SUBJECT: **NEW VEHICLE DEMONSTRATION / DELIVERY HOLD -
 Safety Recall 18S32 - Supplement #3**

Certain 2012-2018 Model Year Focus Vehicles Equipped With 2.0L GDI and GTDI Engines
 PCM Reprogramming for Fuel Tank Deformation

New! REASON FOR THIS SUPPLEMENT

FIGURE 1

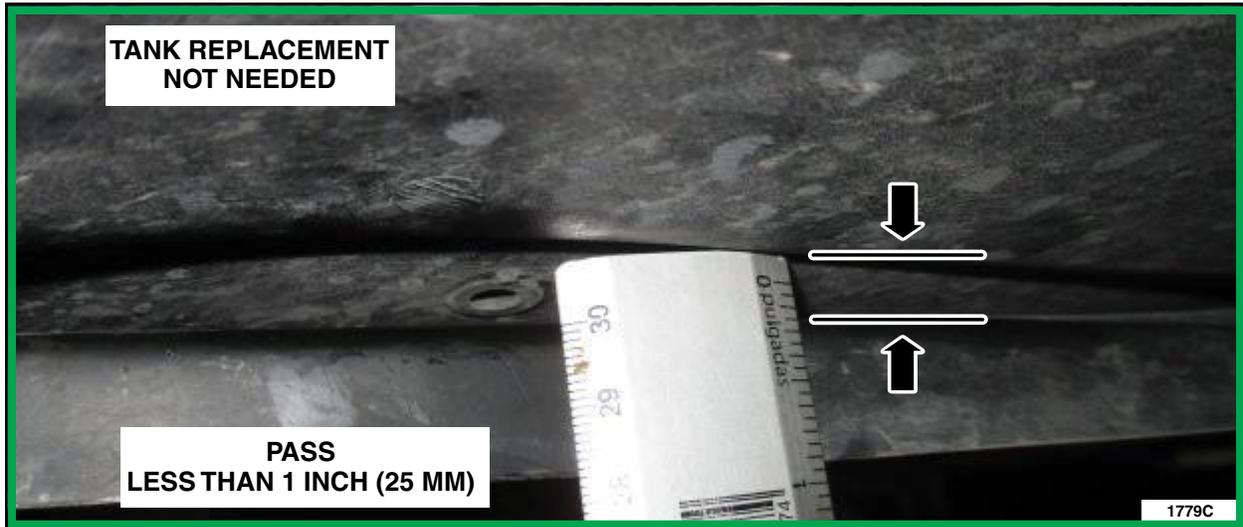
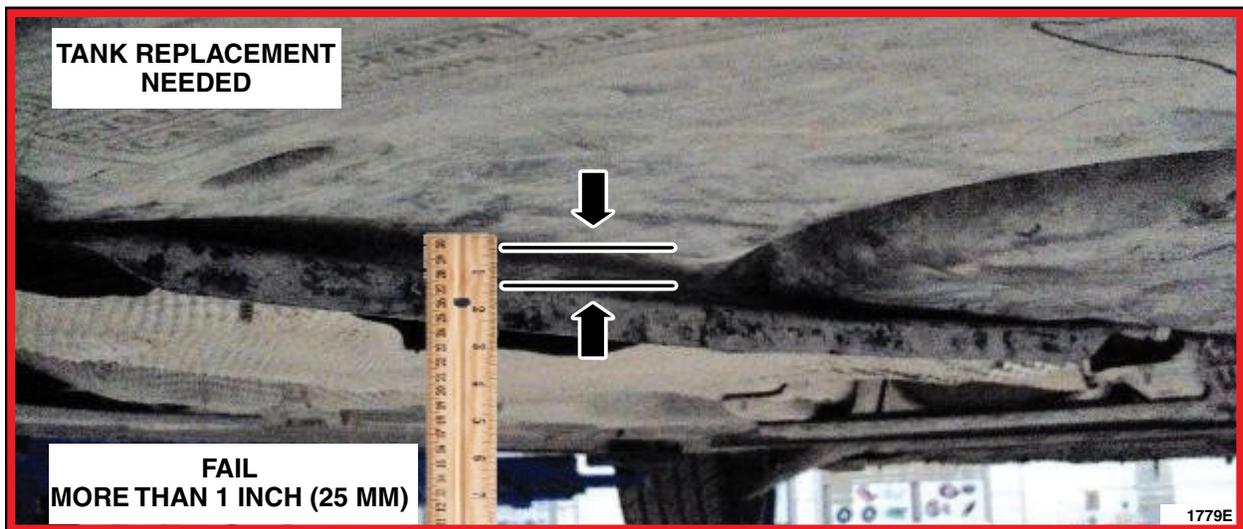
6. Inspect fuel tank for signs of excessive deformation (up to 25mm or 1 inch upward is acceptable). See Figures 1 and 2. Replace the fuel tank and fuel delivery module only if gap is greater than 1 inch upward. Please follow the WSM procedures in Section 310- 01.

FIGURE 5

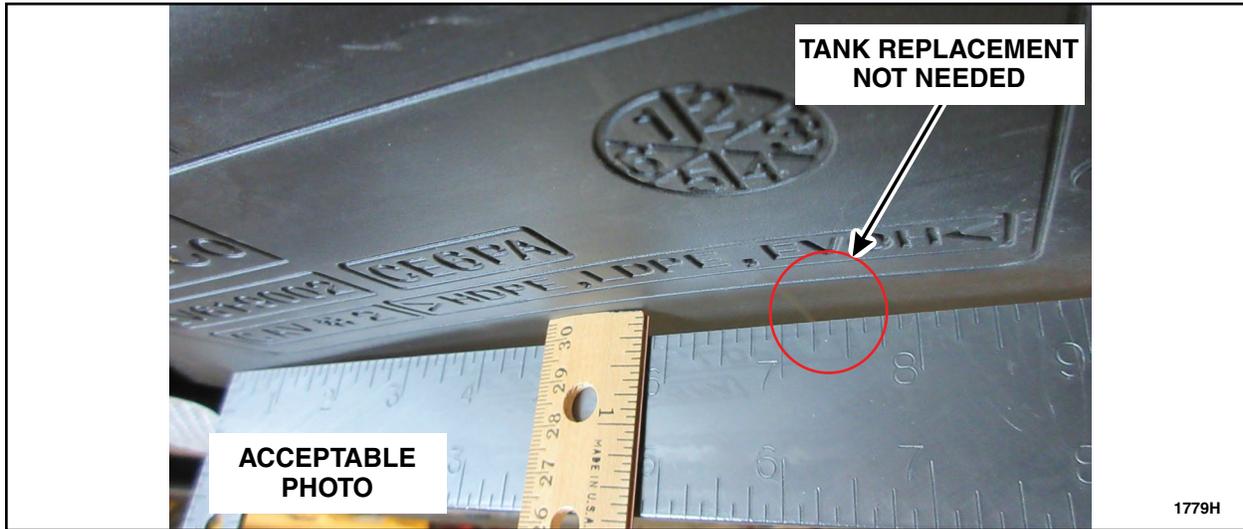
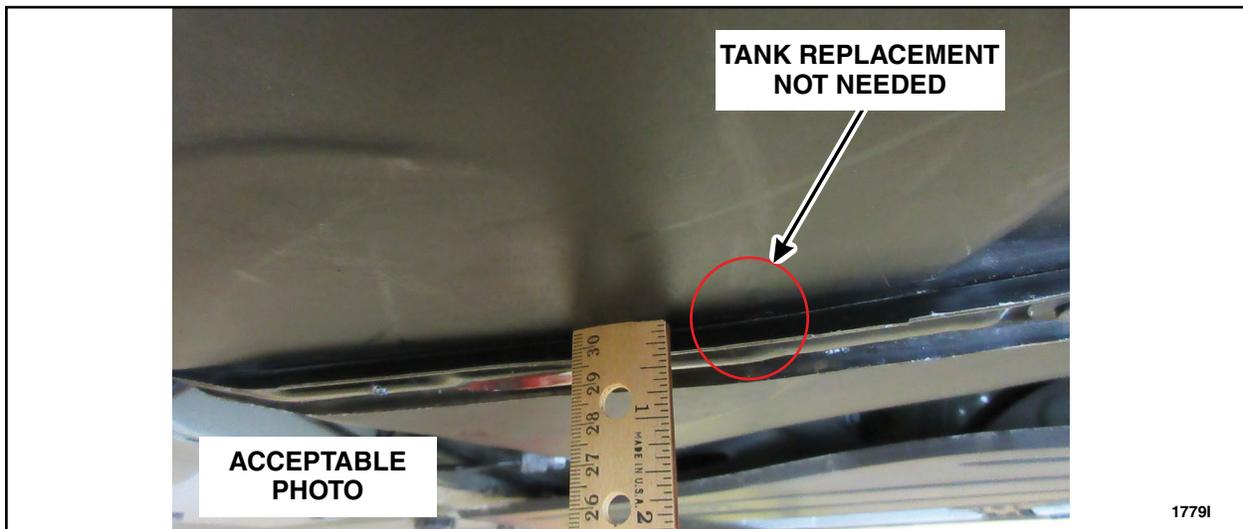
- a. Digital images are now required to be attached to each fuel tank part order. Before submitting VIN-specific part order to SSSC, review new digital image submission requirements on pages 3-4 of Attachment II in the Dealer Bulletin. See Figures 1 through 6 for examples.
